**Appendix T**

**Planning Board Consultants Comment Letters**

Re: Villa at Glen Cove Preliminary Draft Environmental Impact Statement ("DEIS")  
Preliminary Review of Draft Environmental Impact Statement

Re: Villa At Glen Cove Draft Environmental Impact Statement, December 2009  
Review of Revised Draft Environmental Impact Statement

Attachment:

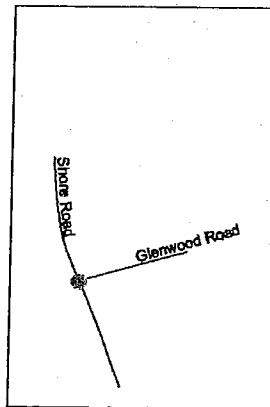
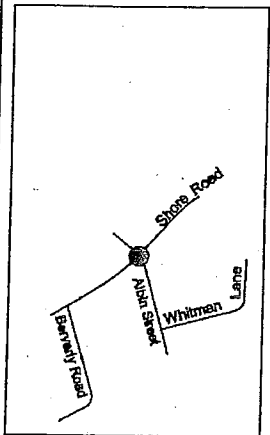
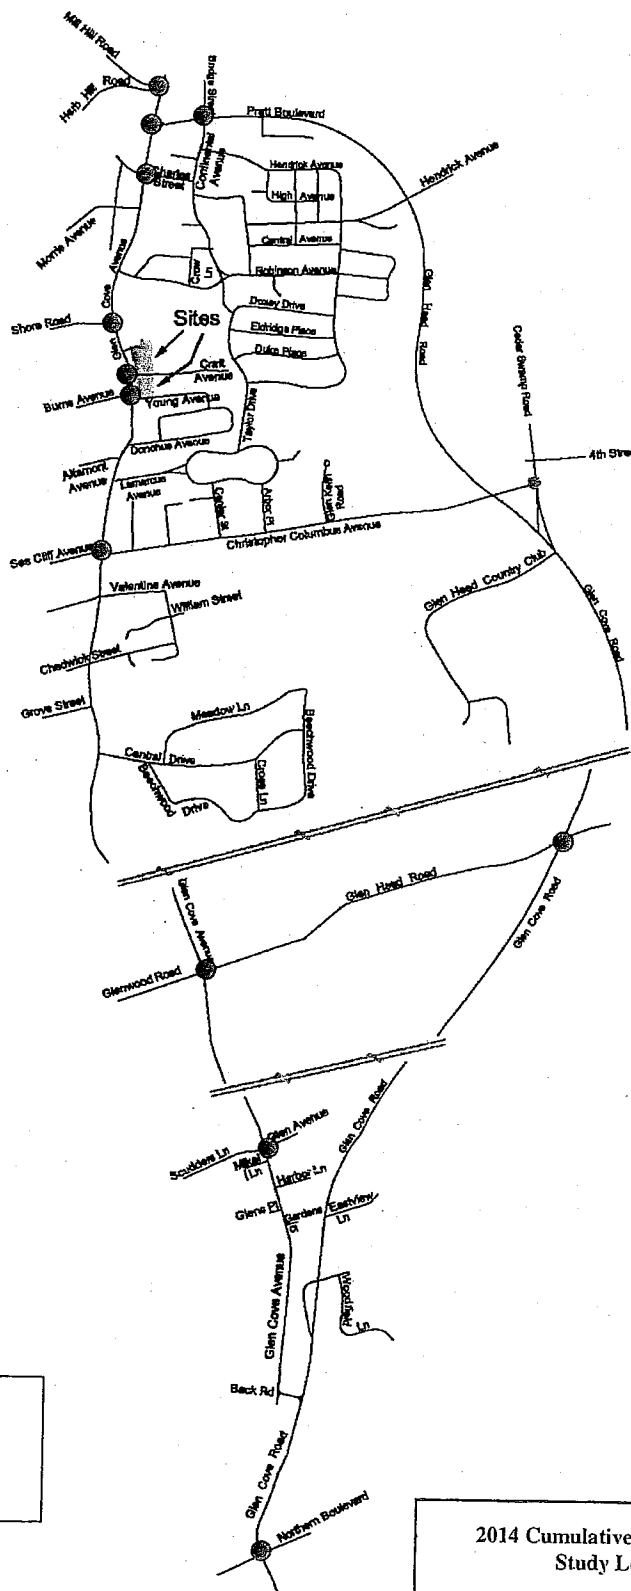
On the basis of these and other relevant factors, we recommend that the following study locations be included in the 2014 Cumulative Traffic Analysis (also see attached figure):
